# Access Compliance Report

## Public Rights-of-Way

Intersection ID: N/A	Main Street: CALAWOOD_WY	Cross Street: BECKSTONE_WY	Location: SE
ADA ID: 6845ADFD6C7B	Ramp Type: BlendTrans1	Initial Pass/Fail: Fail	Overall Compliance: No
		Severity Score: 1.25

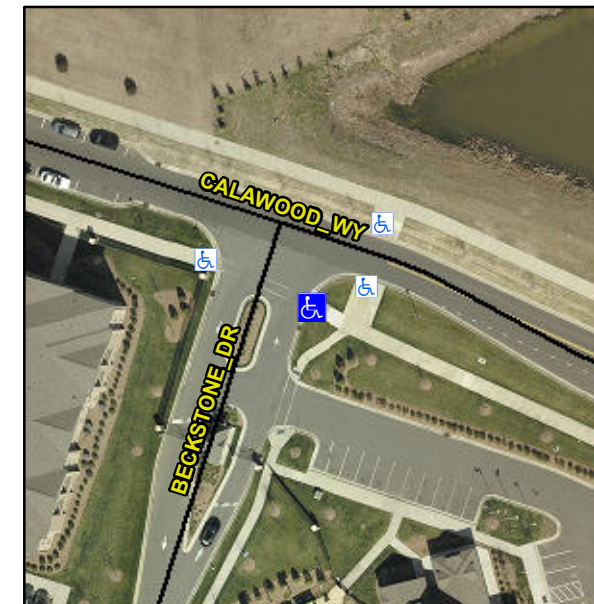
**R304.5.3**

**Remove & Replace Curb Ramp With Two New Directional Ramps or Equivalent.**
